MONTGOMERY COUNTY
PLANNING COMMISSION

July 7, 2025

Re: MCPC #25-0116-001
Plan Name: Gratz College Addition
(860 sq. ft. institutional on approximately 0.53 acres)
Situate: Bala Avenue (south /east of Levering Mill Road
Lower Merion Township

Sheet Title and No.
SITE LAYOUT PLAN

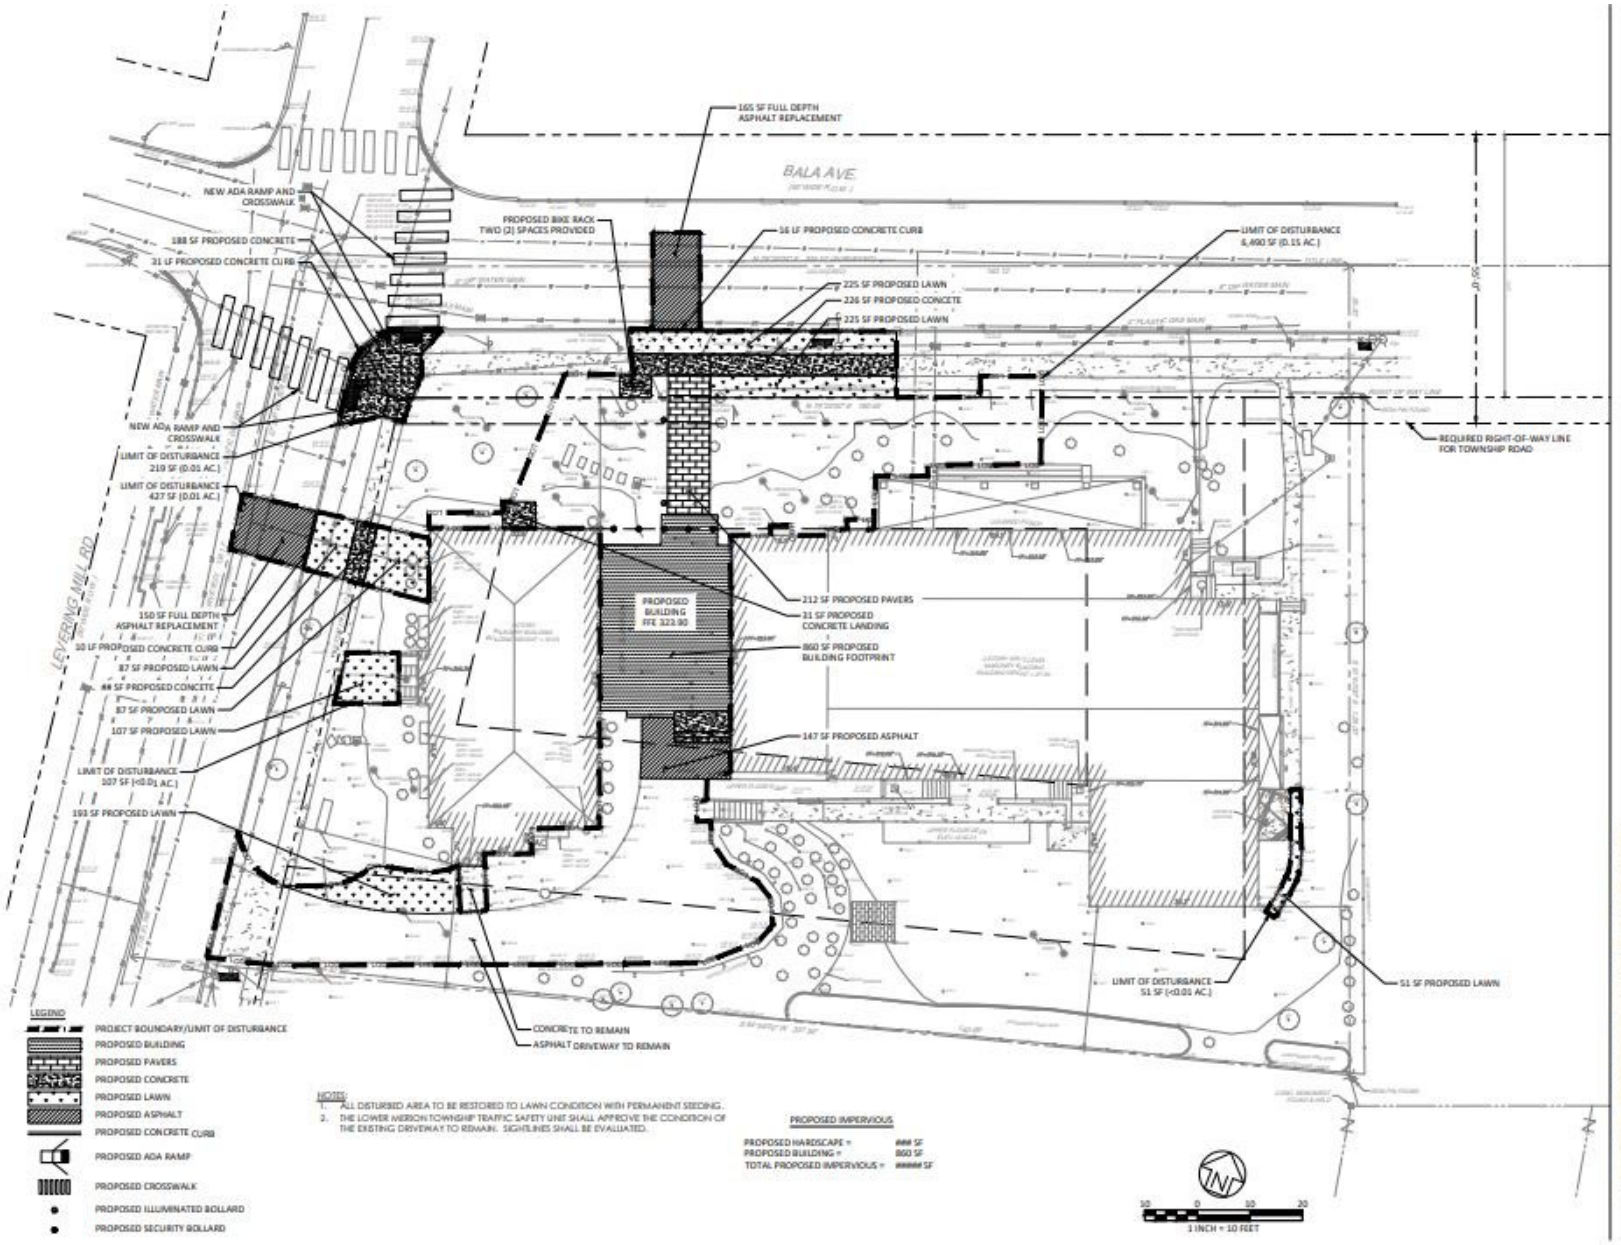
We suggest that the location of the proposed bicycle rack be clarified and shown consistently across the plan submissions. It appears that the bicycle rack near the Bala Avenue pedestrian entrance is shown in different locations relative to the sidewalk on the civil site plan and the landscape plan. In addition, sufficient information should be provided to ensure compliance with the bicycle parking clearance and location requirements in Sections 155-8.8.B. & C. of the township's zoning ordinance.
